MIL-C-11693C
AMENDMENT 4
6 AUGUST 1982

MILITARY SPECIFICATION

CAPACITORS, FEED THROUGH, RADIO-INTERFERENCE REDUCTION, AC AND DC
(HERMETICALLY SEALED IN METAL CASES),
ESTABLISHED AND NON-ESTABLISHED RELIABILITY
GENERAL SPECIFICATION FOR

This amendment forms a part of Military Specification MIL-C-11693C,
dated 8 October 1971, and is approved for use by all Departments
and Agencies of the Department of Defense.

FIGURE 1. Insulation-resistance curve for characteristics - M, -K, -E, and -W.

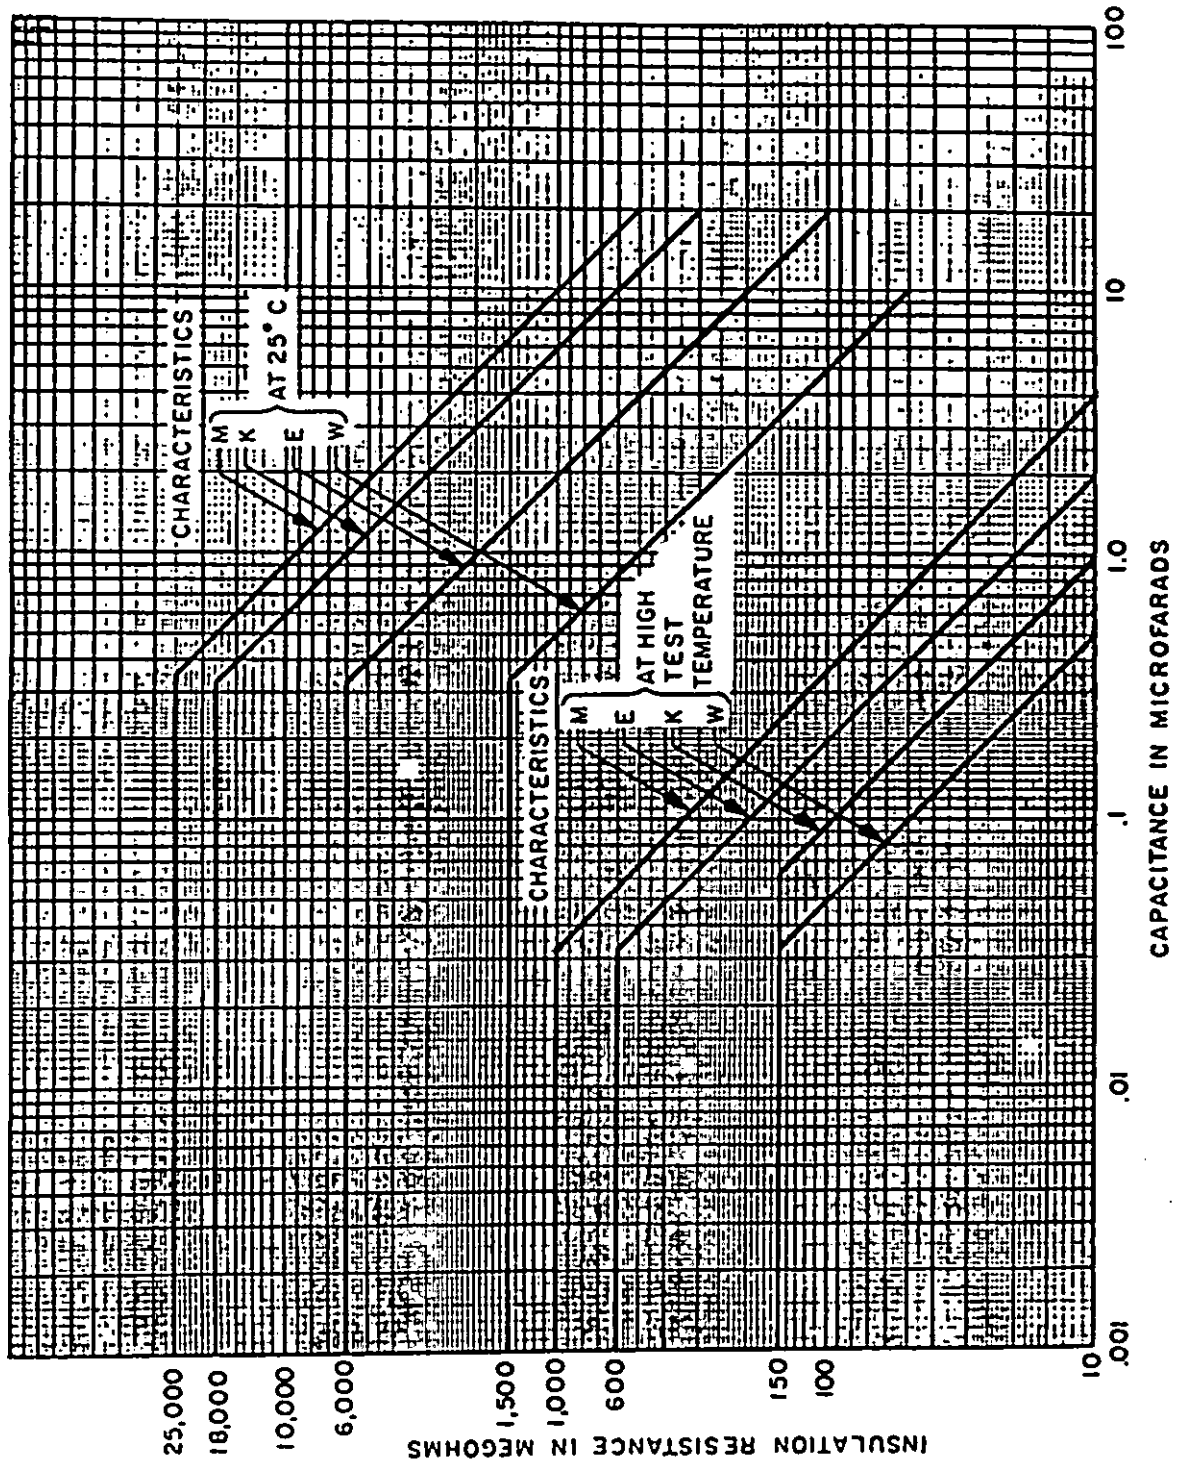
FIGURE 1: Delete and substitute new figure 1 as printed on page 3 of this amendment.
